## PLANNING TECHNICAL REVIEW COMMITTEE –AGENDA

## PLAN SNAPSHOT REPORT WAIV-2023-0006 FOR CITY OF DOVER, N.H.

**RE: Second Street Courthouse – Site Plan Amendment  
10 Second Street  
Dover Planning File: P21-30**

**TO:** Donna Benton, Planner, City of Dover      **DATE:** 6/8/2023  
**FROM:** Neil J. Rapoza, PE  
CIVIL CONSULTANTS  
**SUBJECT:** Plan Revision Memo  
**PROJECT:** 20-279.00 One First Street, LLC (Dover project #P21-30)

**LP4**

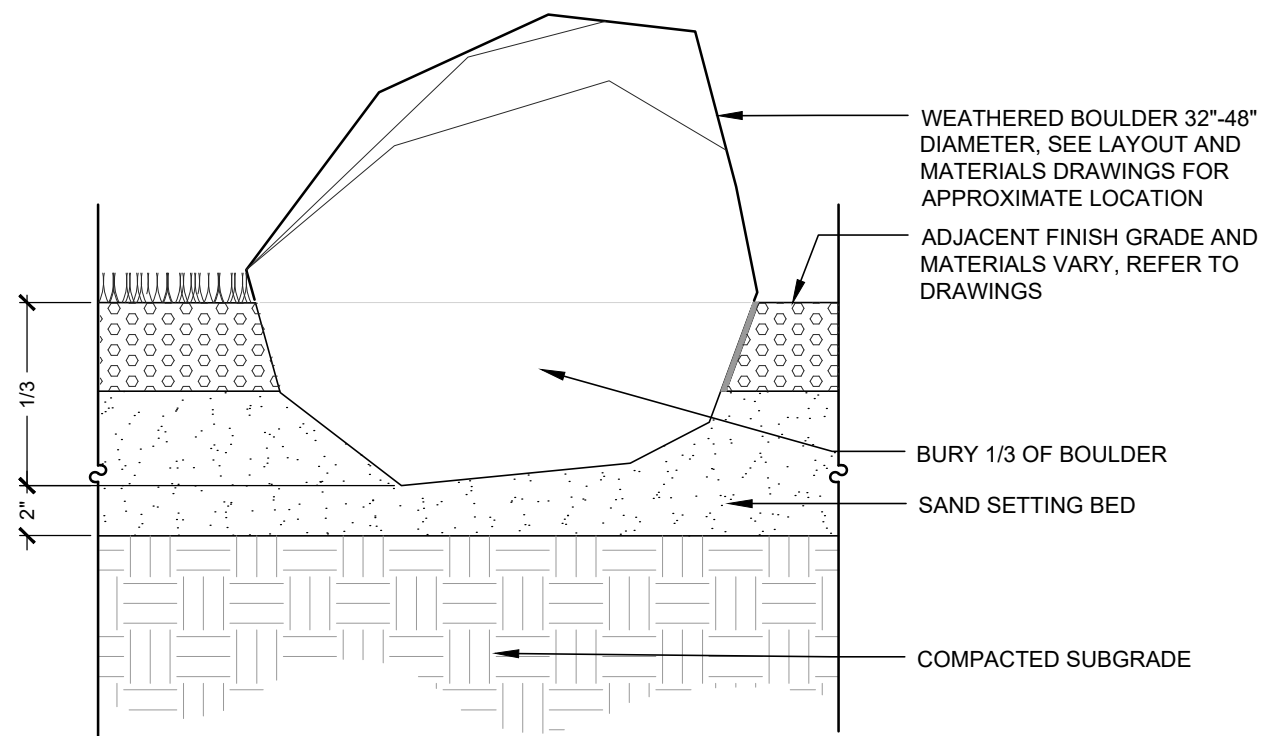
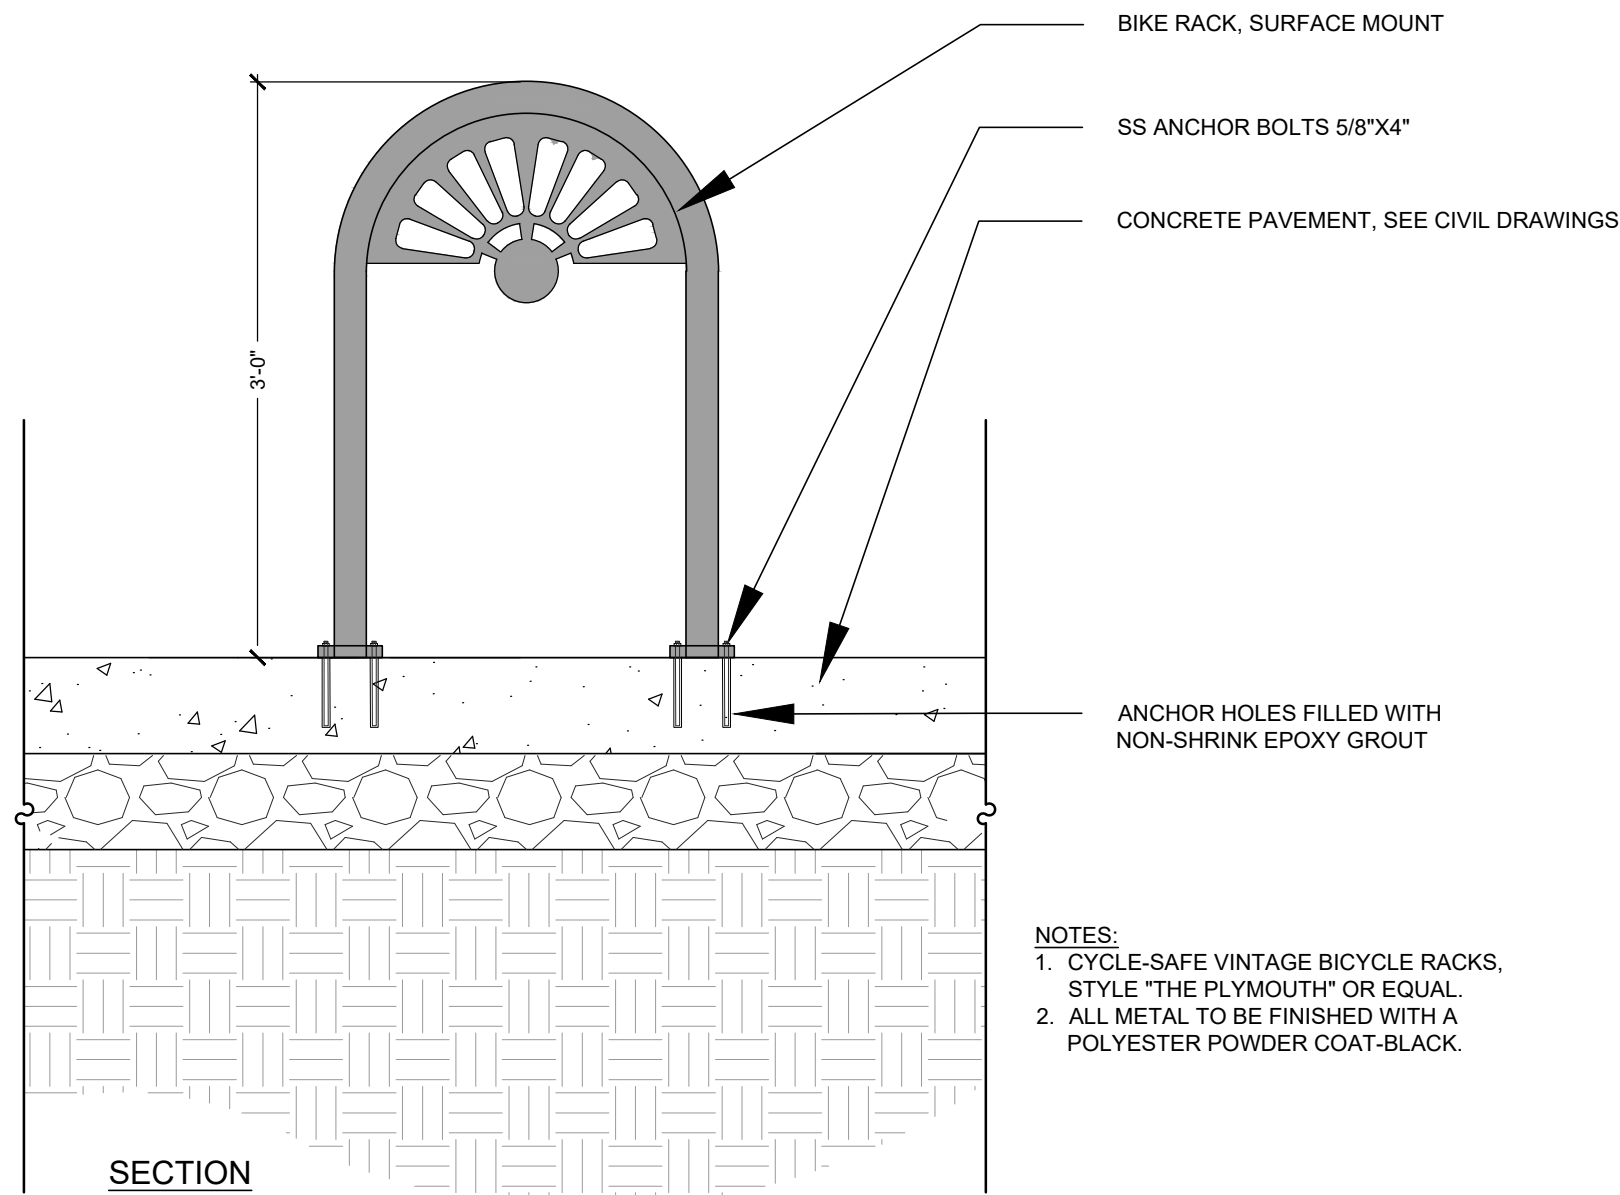
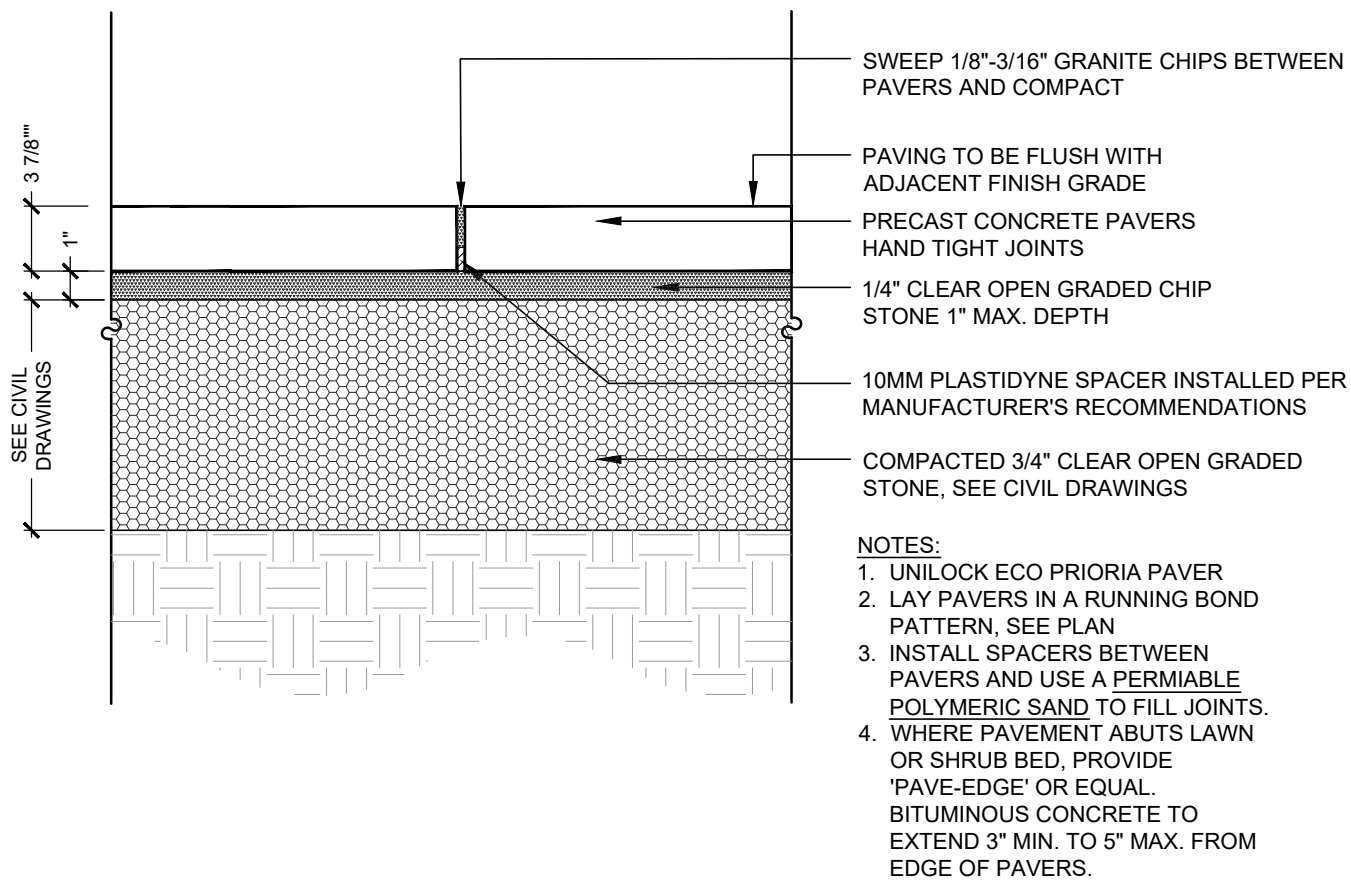
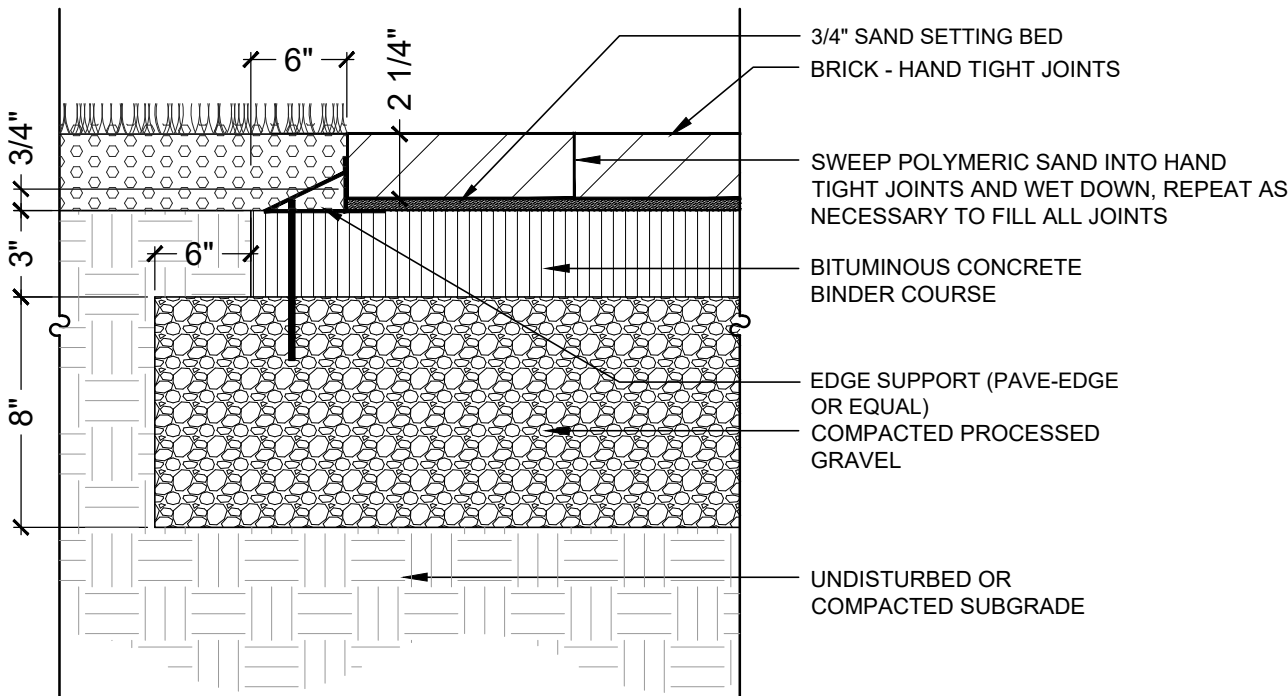
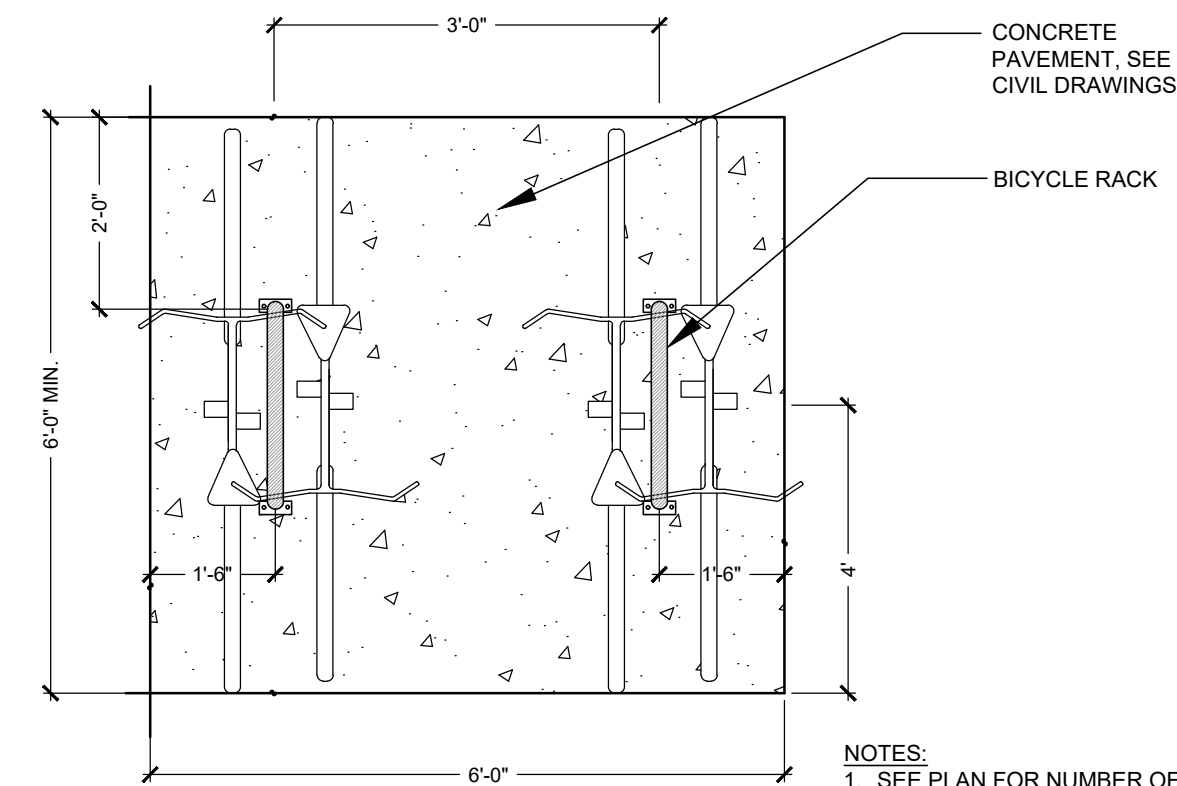
### Sheet LP4

- a. Removed concrete unit paver detail.
- b. Added brick pavement detail.
- c. Added note for spacers and fill joints for porous concrete paver detail.

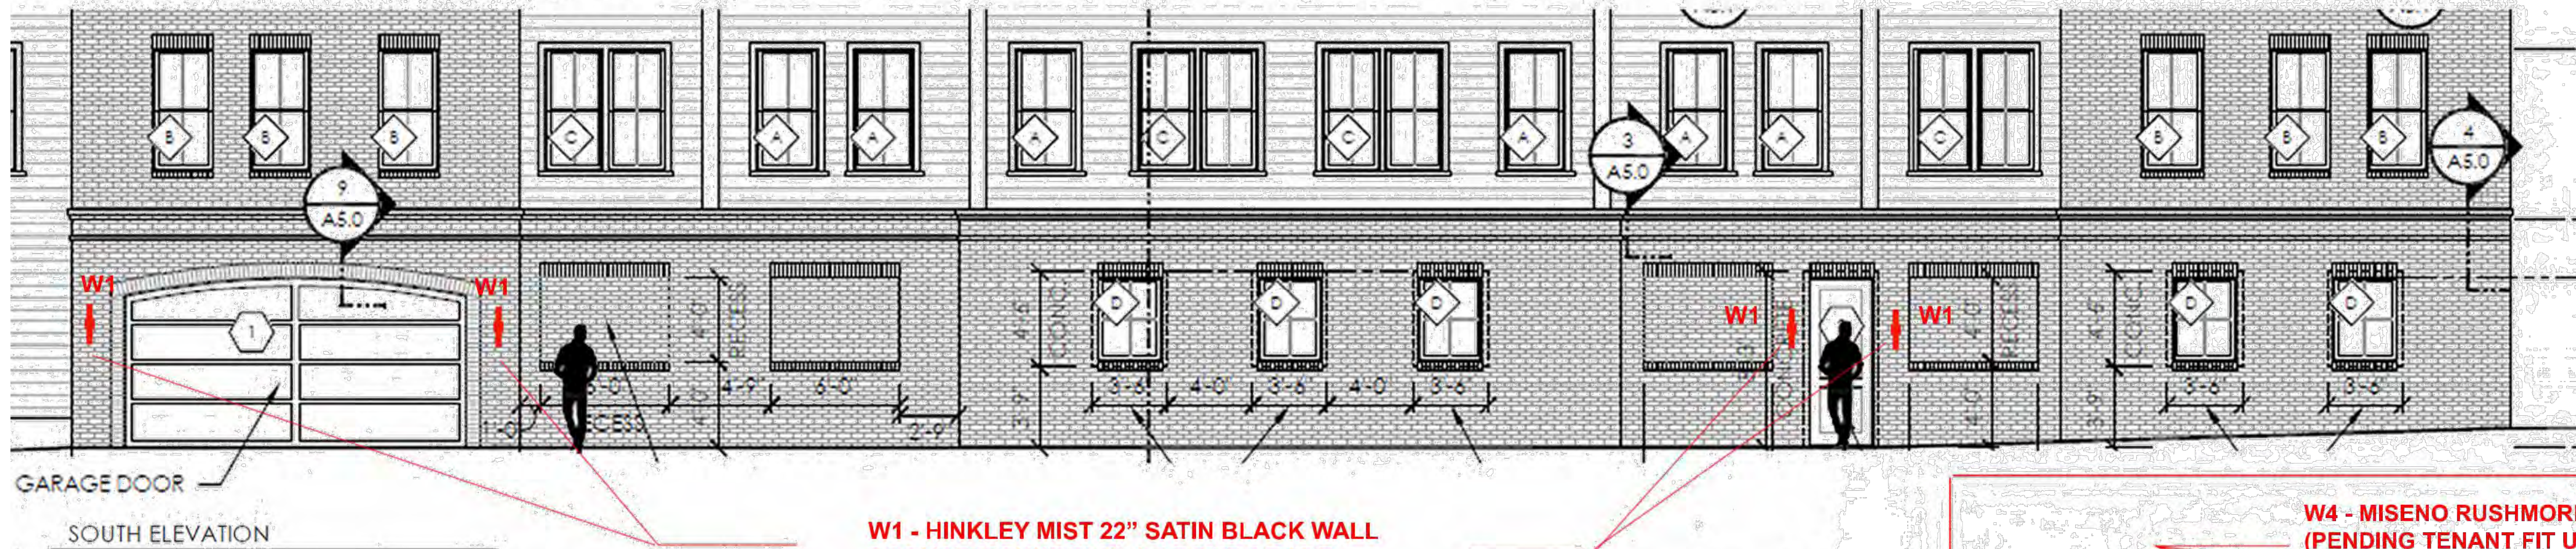
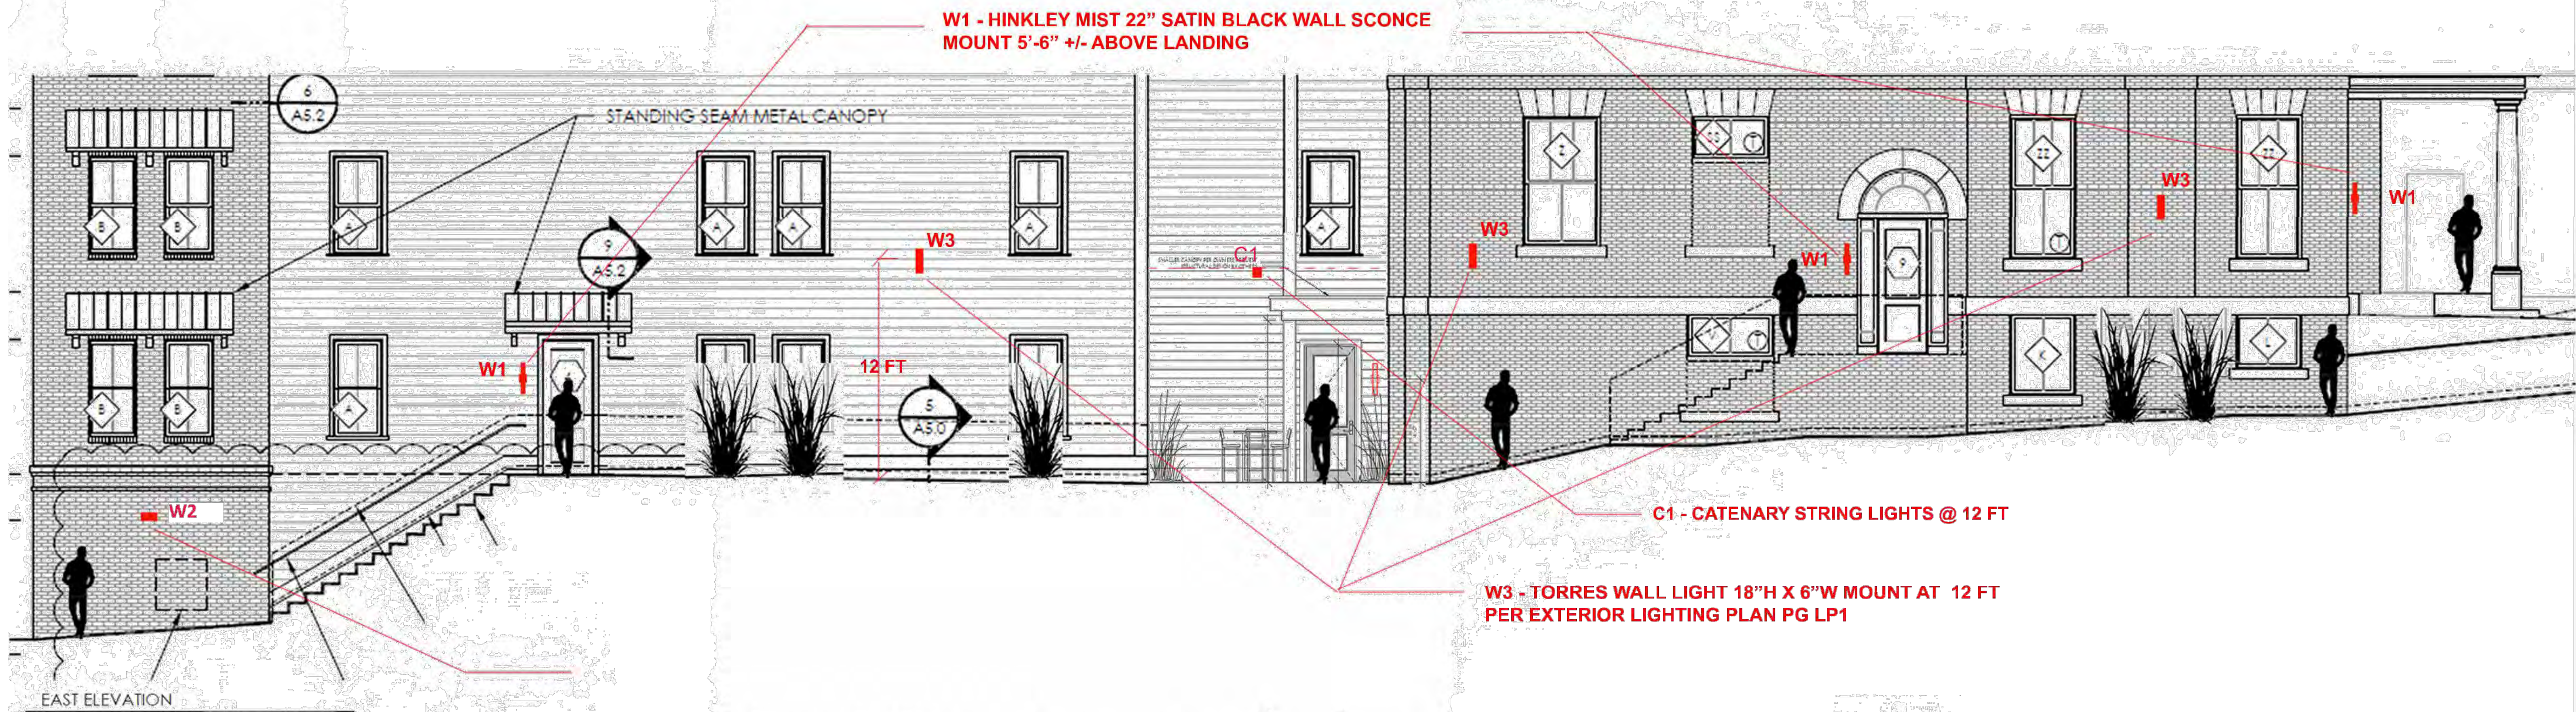
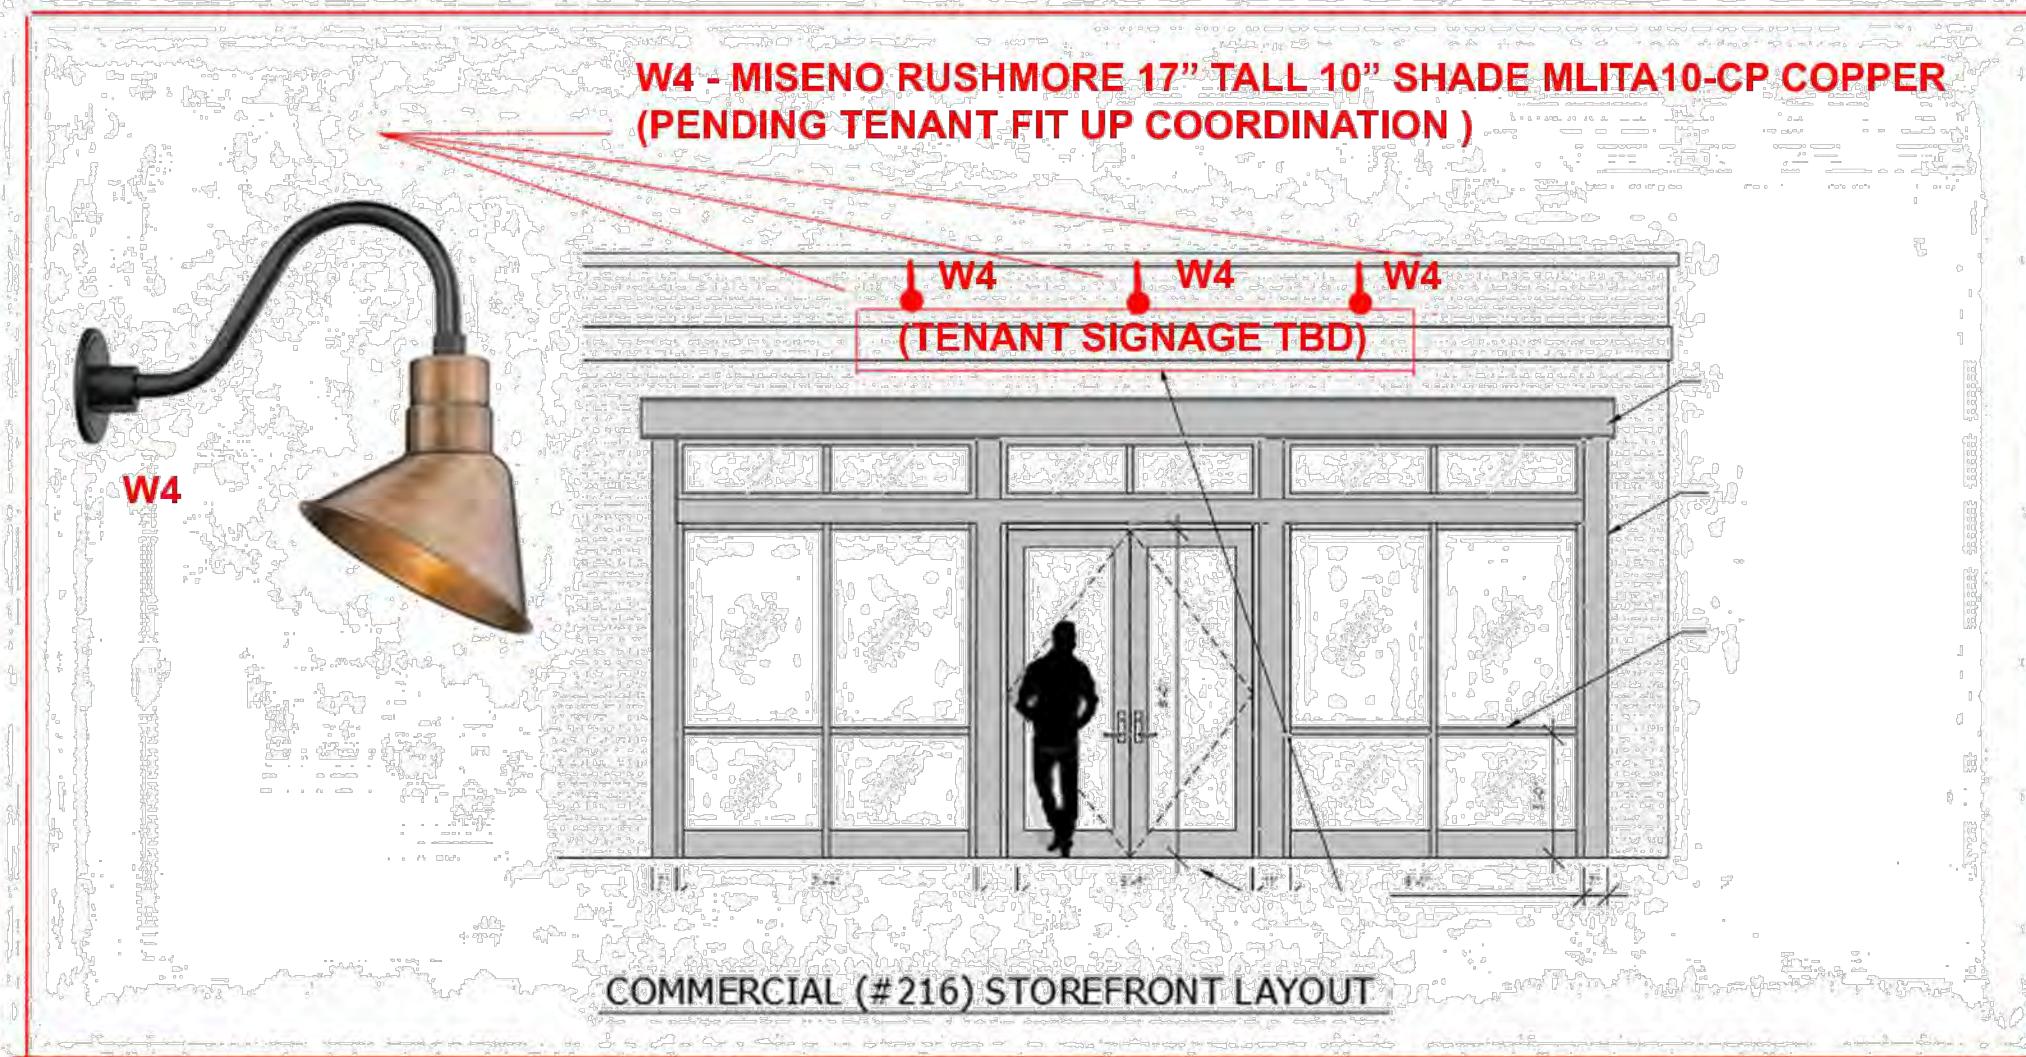
### Sheet LP6

- a. This sheet added to indicate lighting elevations and fixture depictions, South and East elevation of building.
